1822 Bank Street

URBAN DESIGN BRIEF - R2

MARCH 17, 2025

RESPONSE TO URBAN DESIGN COMMENTS

VIEW FROM ABOVE NORTHWEST SHOWING 45 DEGREE ANGULAR PLANE

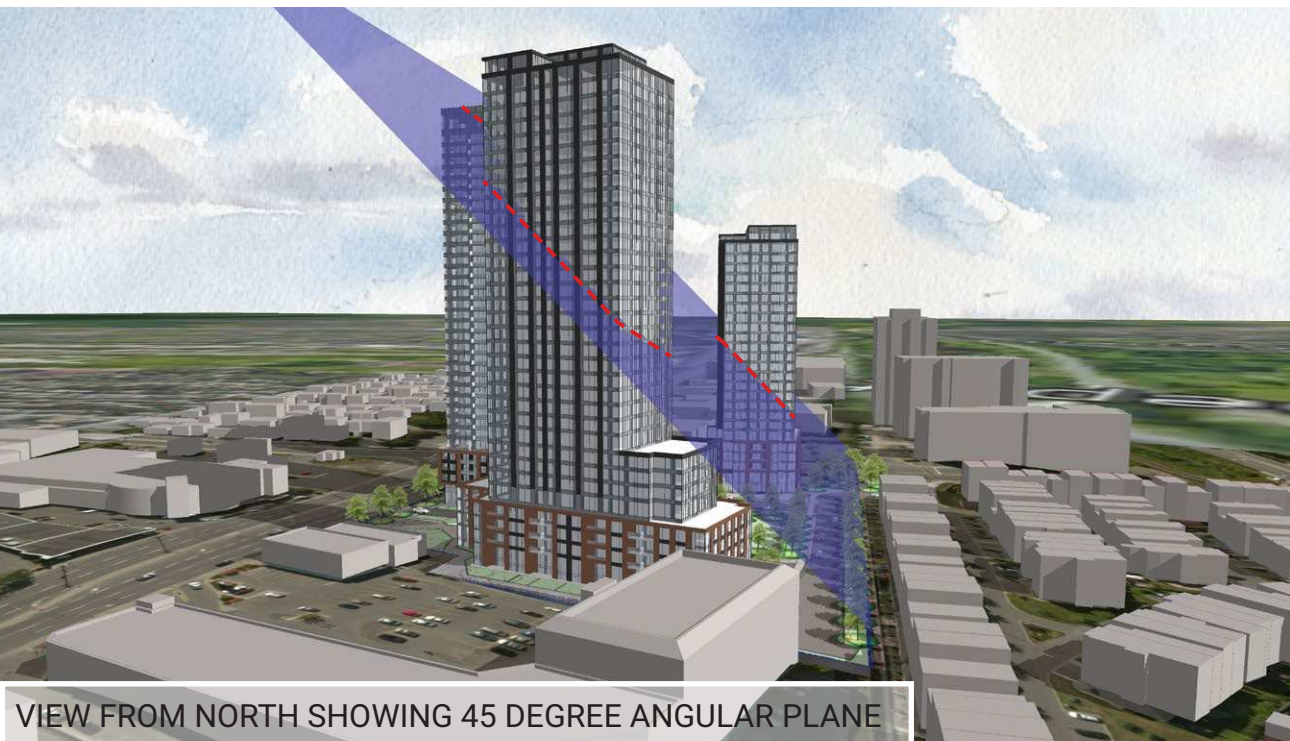
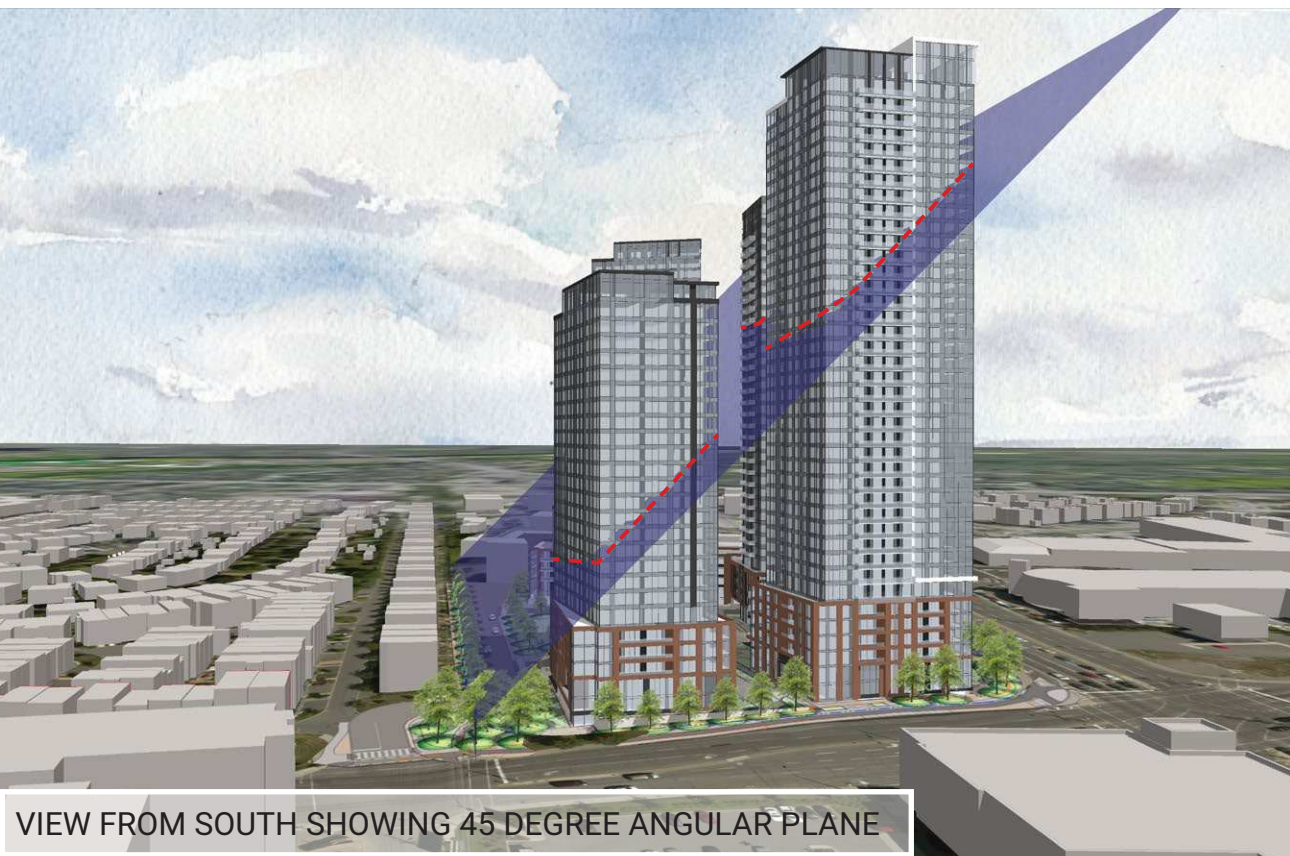
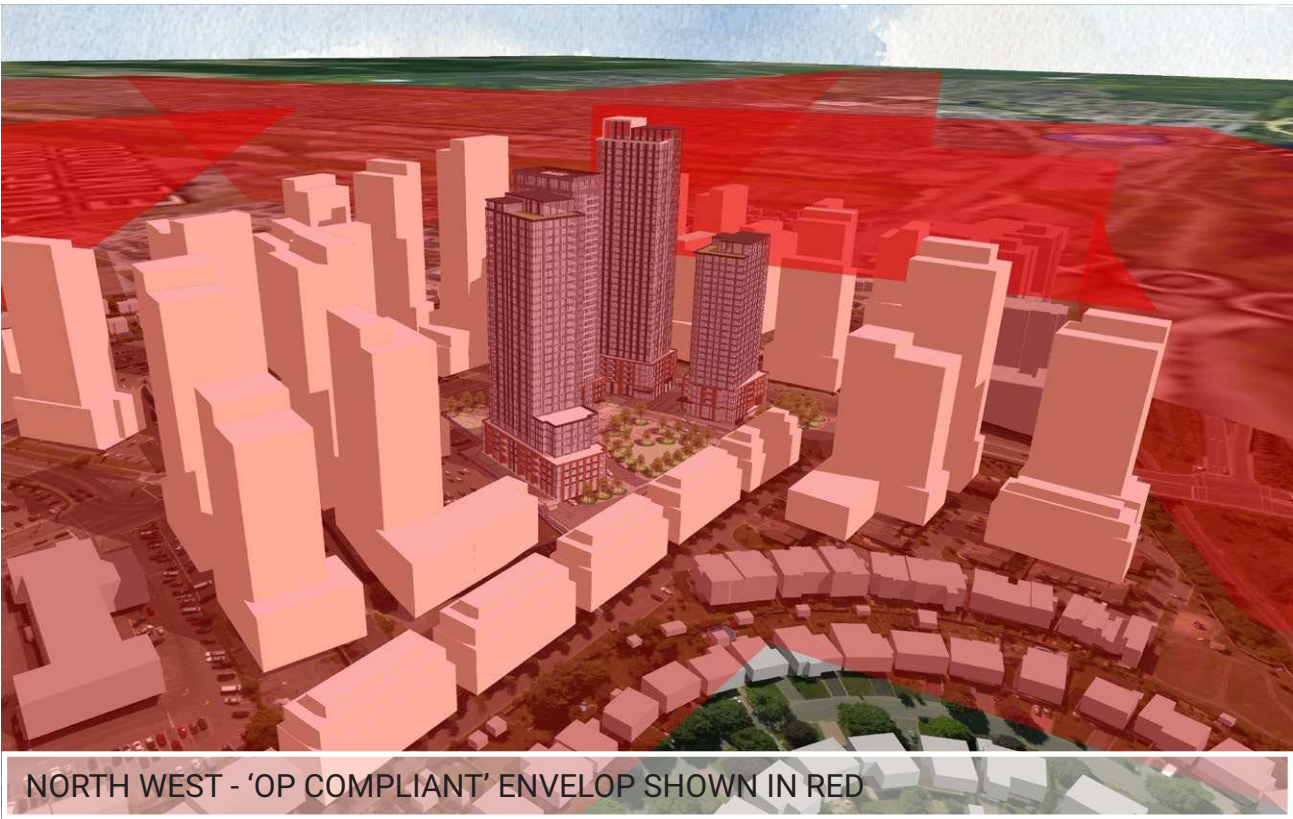
41. Ensure effective built form transition, guided by the application of angular planes.

17. Towers 1 and 4 protrude significantly above the 45-degree angular planes as shown on page 20 of the submitted Design Package.

- i. Tower 1 – At the current proposed location and floorplate size, the height of the tower appears to be too tall.
- ii. Tower 4 – The height should be reduced. It is interesting to note that if Tower 4 is a 16-storey building, permitted by the Secondary Plan, it will not protrude above the angular plane.

28. Slide 20 of the Design Package demonstrates the buildings projecting above the angular plane. While the angular plane is not meant to be a rigid determination of heights, it does inform the general appropriateness of building heights. In this case, it seems to me that Building 4 should be reduced by several storeys. In addition to improving the building height transition, this would add more variation to the building heights.

Applicant: Please refer to the angular plane diagrams included in the UDRP submission set. We feel that the proximity to the transit station and future development potential under the OP justifies some elements of the development breaking the 45 degree angular planes. The trade-off the proposed development offers is providing the majority of the western edge as greenspace. This minimizes the number of the existing townhomes impacted by overlook / shadowing.

Applicant: We acknowledge that towers 1 and 4 protude through the angular plane. However we feel that this massing response is reason given the significant adjacent open space gained by locating the park at the west side of the property closest to adjacent low-rise. The park location serves to balance the impacts of the taller building forms. Additional, building 1 is the closest of the buildings to the new transit station, and therefore an appropriate location for a taller / higher density form.

FUTURE DEVELOPMENT POTENTIAL

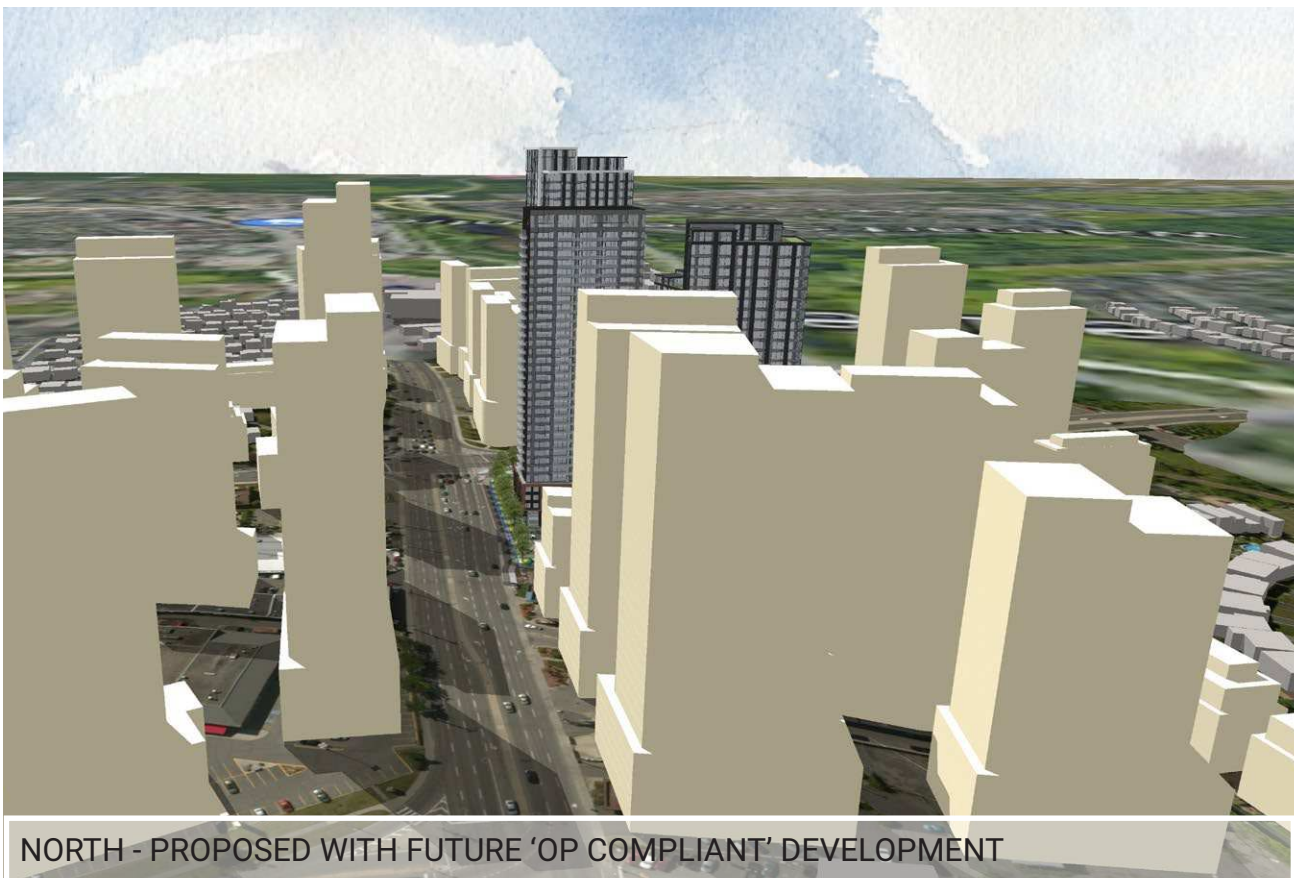
12. Images shown on pages 21 and 22 of the document named "Design Package" appear to be arbitrary and unrealistic. They can also be misleading in terms of understanding the context within which the proposal is evaluated.

Applicant: Images on Pages 21 and 22 (Pages 35-36 on the updated Urban Design Brief) were provided at the request of City of Ottawa Planning staff. They illustrate the proposal in the concept of future development potential as recognized by the Official Plan at a point sometime in the future.
